UNITED STATES  
NUCLEAR REGULATORY COMMISSION  
REGION II  
101 MARIETTA STREET, N.W.  
ATLANTA, GEORGIA 30323

Report Nos.: 50-280/90-11 and 50-281/90-11

Facility Name: Surry 1 and 2

SUMMARY

RAYCHEM BREAKOUT SPLICE  
WITH  
ROSEMOUNT CONDUIT SEAL  
FIGURE NO. 10

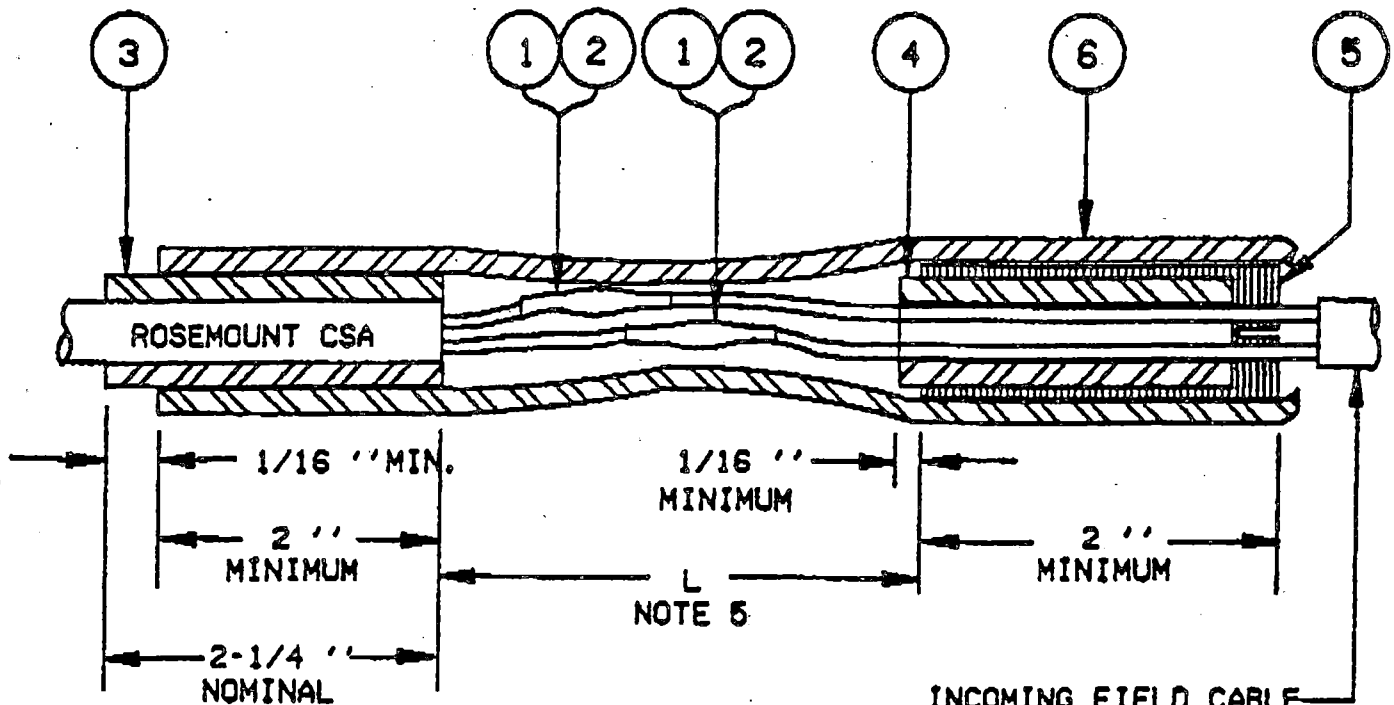
The Raychem splice, as shown in the attachment, is used on Rosemount conduit seal connectors inside containment. There are six (6) of these splices in Unit 1 and fifteen (15) splices in Unit 2. This splice design is used whenever the licensee replaces an existing Conax conduit seal connector with a Rosemount, model 353C, conduit seal connector (CSC). This occurs whenever the transmitter is replaced. Both the Conax and Rosemount CSCs are EQ qualified but the Conax is difficult to disassemble in the field; therefore, the licensee is replacing them.

The Raychem splice is an unusual design that was necessitated by the unqualified inline butt splice (items 1 and 2 in the attachment) and the fact that the licensee did not want to seal on the jacket of the incoming field cable. The inspector considers the splice to be qualified because all the Raychem parts that make it up are individually qualified in similar applications. The term "splice" as used is somewhat of a misnomer when in actuality the design should be called an enclosure.

Discussions were held with I&C supervisors and specifically the supervisor that participated in the telephone call to Raychem. To the best of his memory and with the aid of notes, Raychem did point out that the butt splice (items 1 and 2) would be considered unqualified by them (Raychem). With respect to furnishing "engineered kits", Raychem pointed out that the VEPCO design was unusual and that they would not have designed it as such for the particular application. Furthermore, "engineered kits" furnished by Raychem are kits involving designs done by Raychem. The supervisor stated that Raychem did not pass judgement on the adequacy of the overall configuration.

The inspector agrees with the licensee that the subject splice, even though it is an unusual design, is qualified for the intended use as a water/moisture proof enclosure for the two (2) unqualified inline butt splices. The concern was not substantiated.
